ADDENDUM
NO. 3

April 17, 2026

**TRI-TOWNSHIP WANATAH SCHOOL
RENOVATION AND RELATED WORK
Wanatah, IN 46390**

This Addendum consists of Pages ADD 3-1 through ADD 3-4, and attached Addendum No. 3 from Gibraltar Design dated April 16, 2026 and consisting of 5 pages, replacement Specification Section 33 40 00 - Storm Sewage Systems, and 15 drawings.

BOYS LOCKER ROOM DEMO PLAN
2
1/4" = 1'-0"

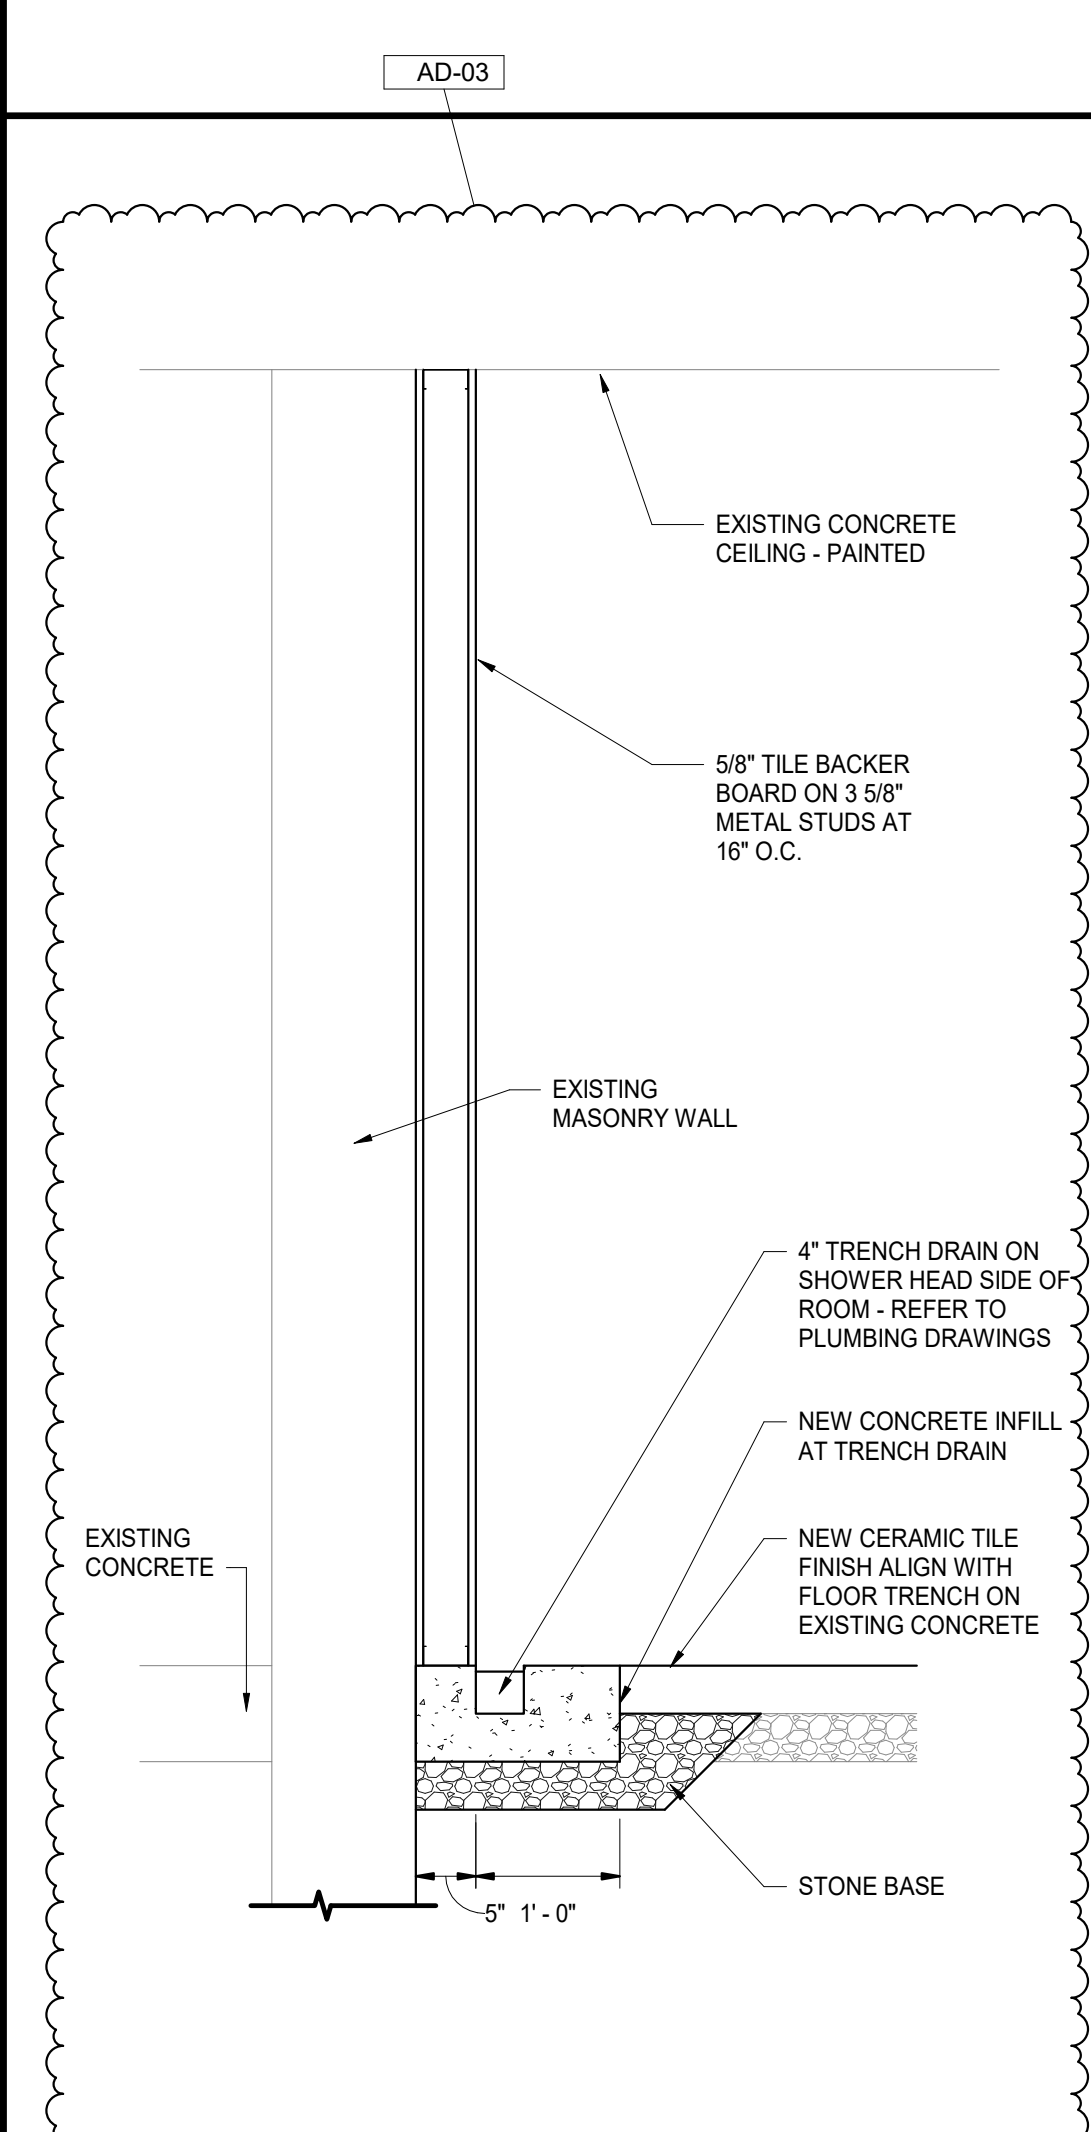
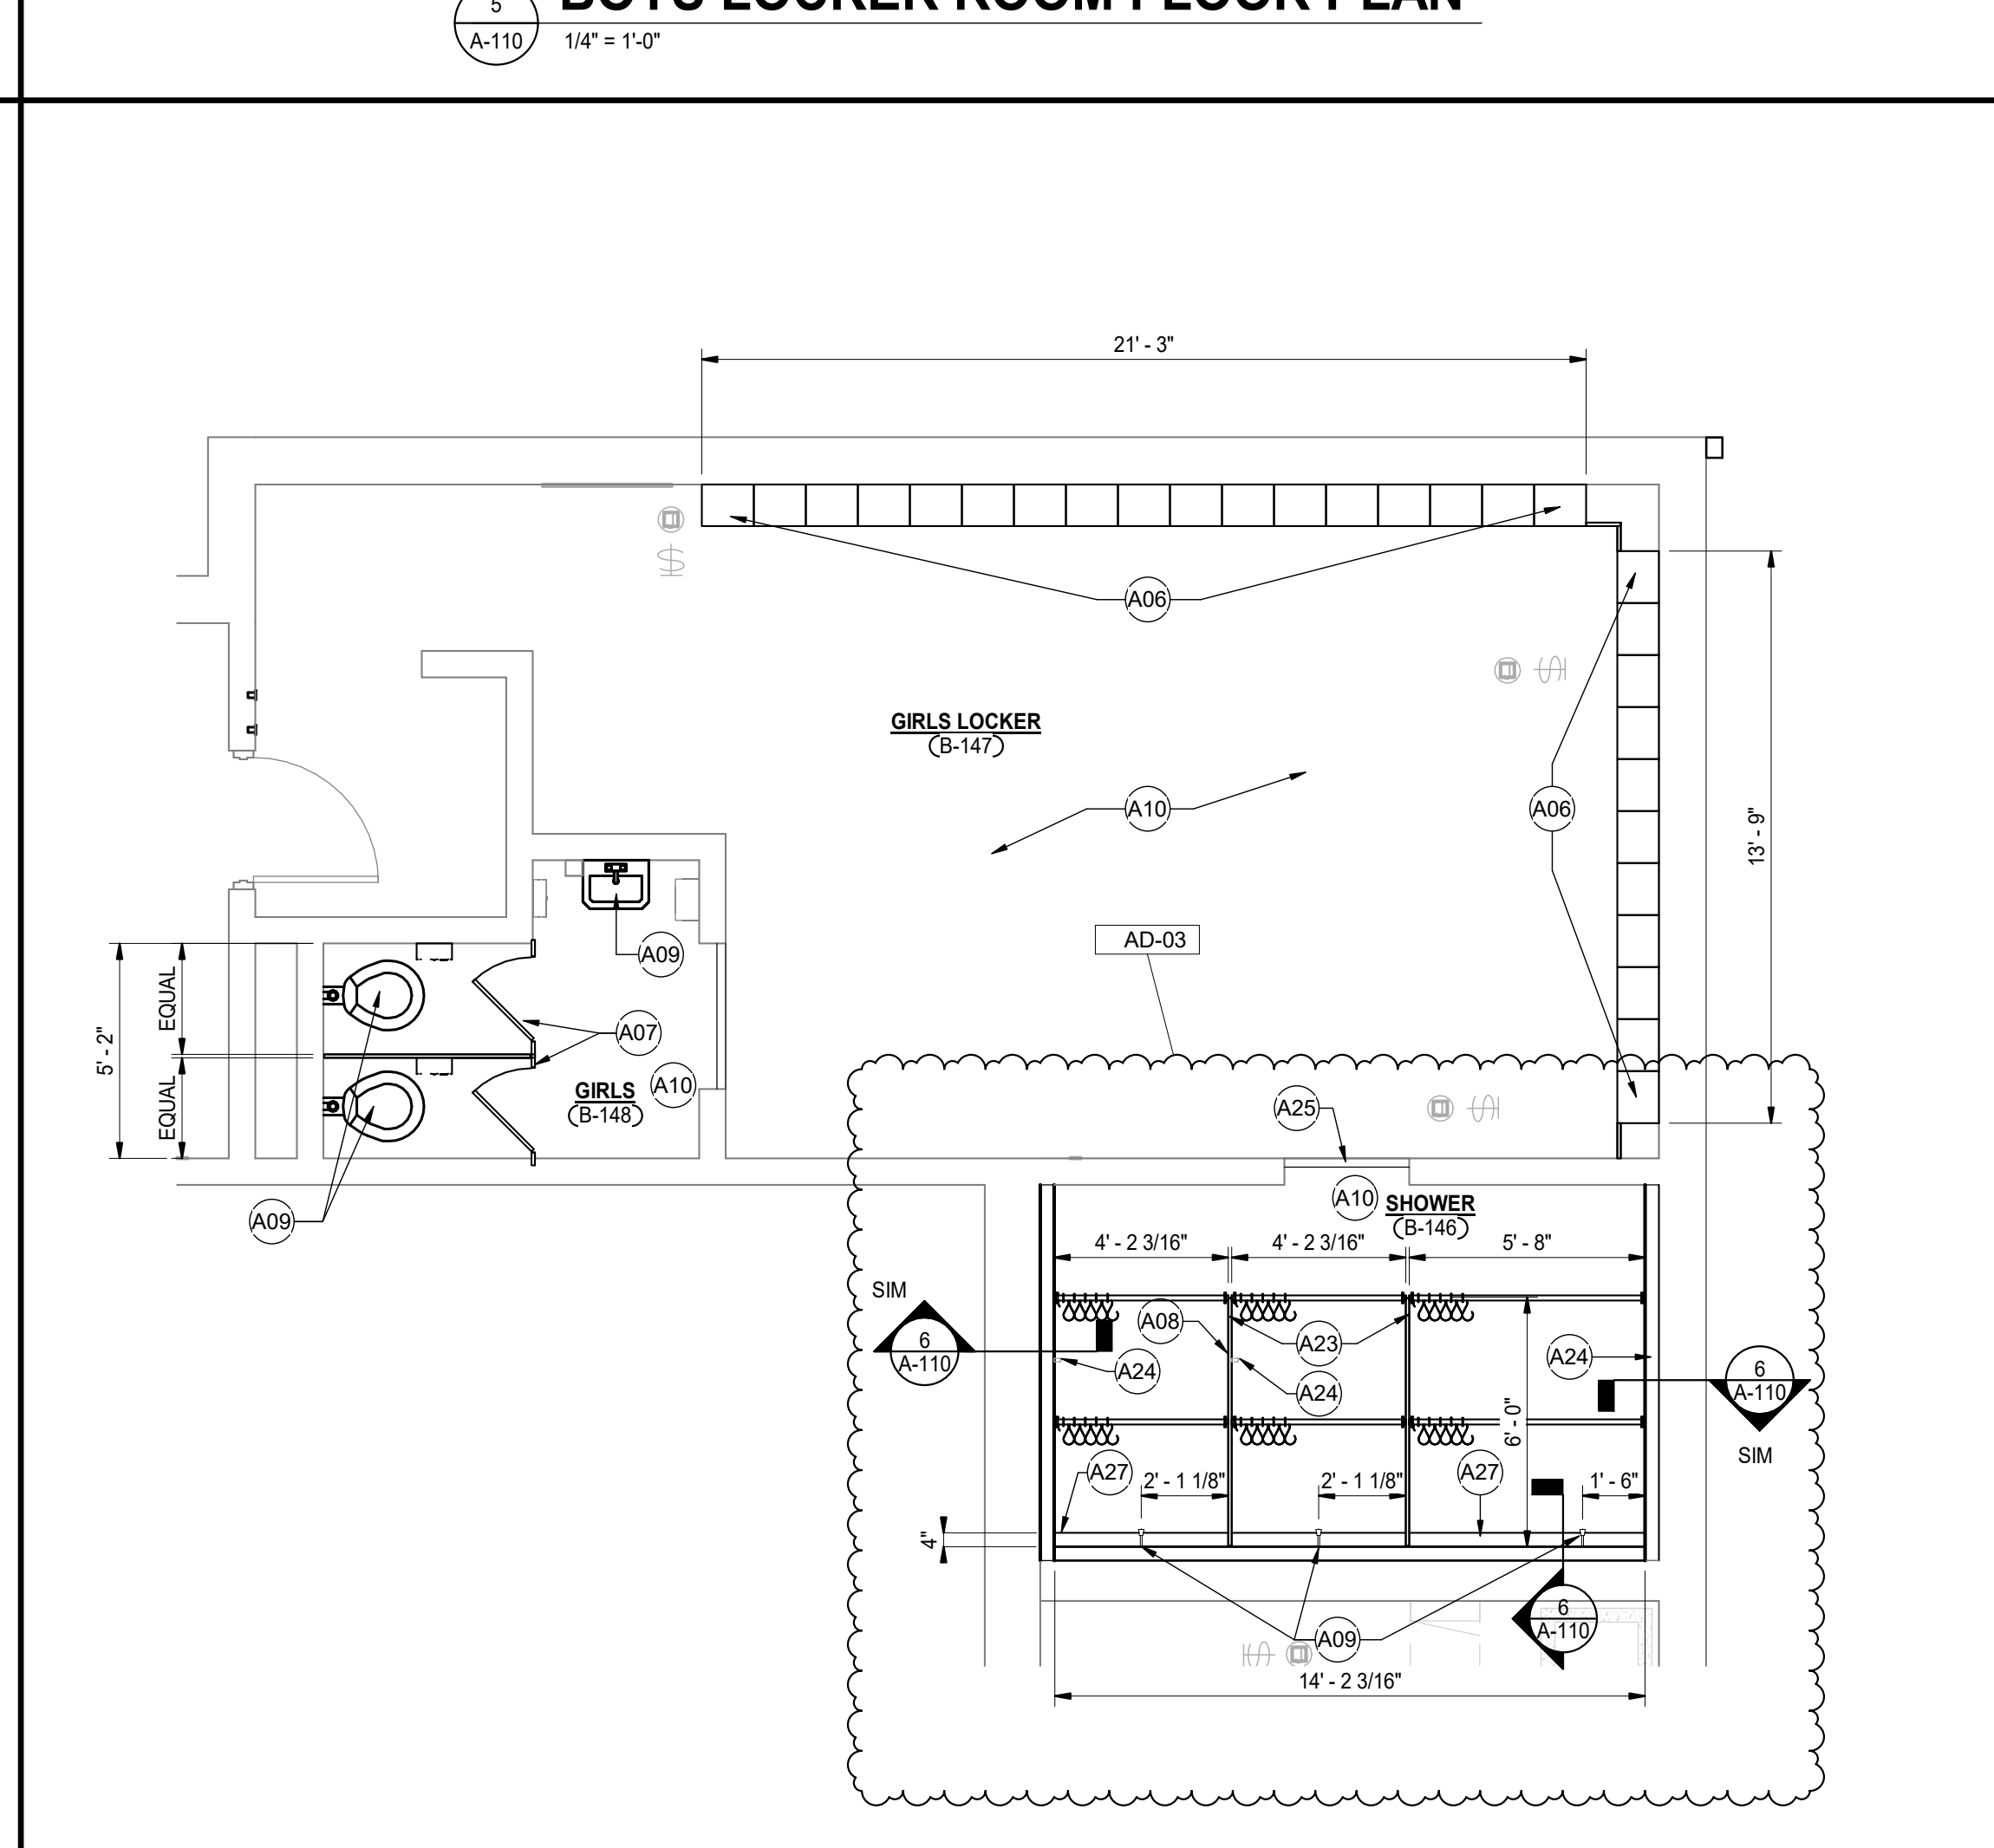
17. Sheet A-110

- A. Refer to revised, full-size drawing, for clarifications to wall framing, trench drain, and wall section detail for Shower Rooms B-146 and B-155, included in this Addendum, for clarifications.
